Subject: February 2010 Inspection Report, Cameco Resources, Permits 603 and 633

FEBRUARY 2010 INSPECTION REPORT DISTRICT 1/LAND QUALITY DIVISION

COMPANY:	Cameco Resources (CR), Highland Ranch, Permit #603 & Smith Ranch, Permit 633
LOCATION:	North of Glenrock, off Ross Road
DATE OF INPECTION:	February 24, 2010
DATE OF REPORT :	March 2, 2010
INSPECTORS:	Pam Rothwell, LQD Permit Coordinator
CONDITIONS:	Very Cold in A.M. (5°), warming to upper 20s in P.M. Partly cloudy, light wind, snow pack field conditions
COMPANY REPRENTATIVES:	Dawn Kolkman, SHEQ Coordinator John McCarthy, Radiation Safety Officer

Figure 6 View of new disturbance for DDW#10

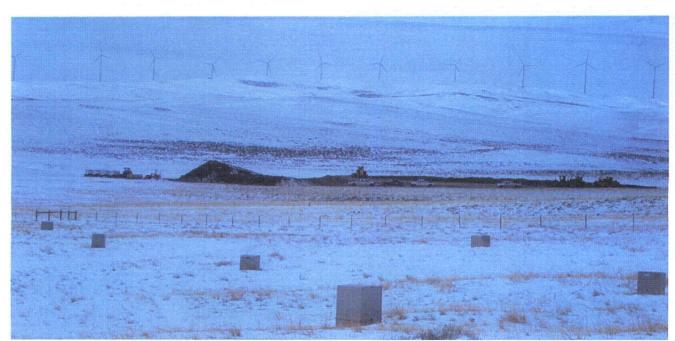
New disturbance was discovered west of MU-4 including several loaders and other construction equipment and multiple pick-up trucks indicating contractor work. A large stockpile was noted from the distance and presumed to be topsoil stripped from the area (Figure 6). It appeared the dozers were excavating from a depression and pushing the material upslope. Upon return to the office to inquire what the disturbance was related to, CR explained it was the development of the Deep Disposal Well Pad #10.
